修改事项1: 首层通道入口处增加管理门。

修改事项2：本工程油烟井局部修改为新风井。

修改事项3: 地下室地铁接驳口增加玻璃联通门。

S1#楼一层局部平面图 1:100

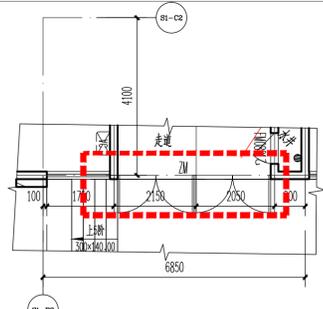
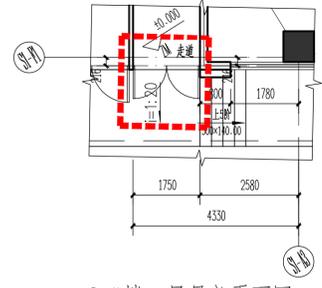
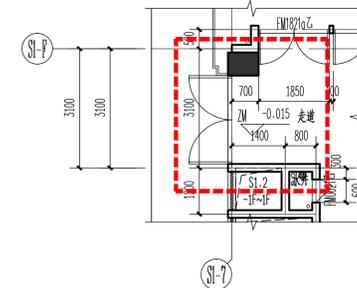
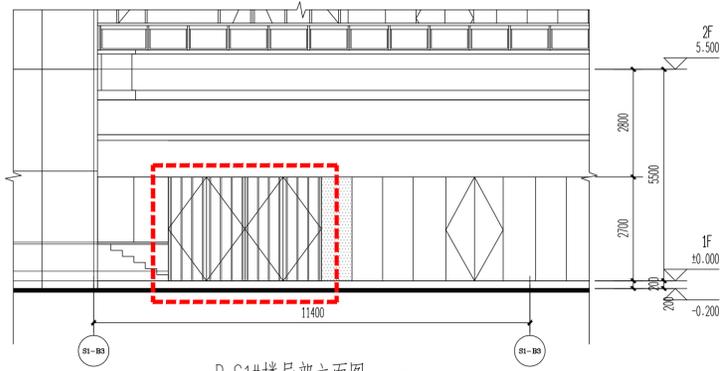
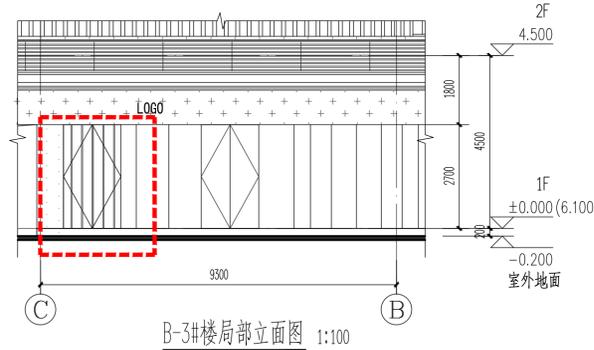
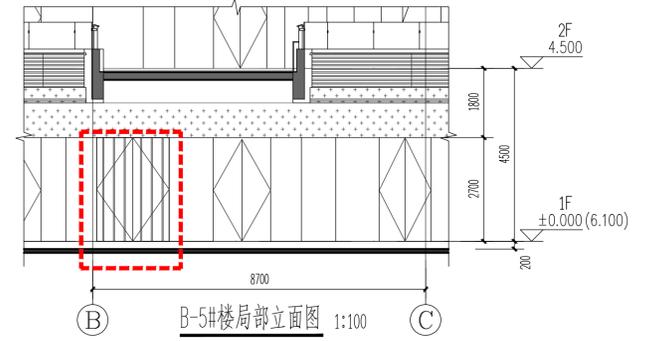
修改事项1: 首层通道入口处增加管理门。

注: 本图所有平面中编号ZM门均为由内侧可向外自由开启的通透式平开门。
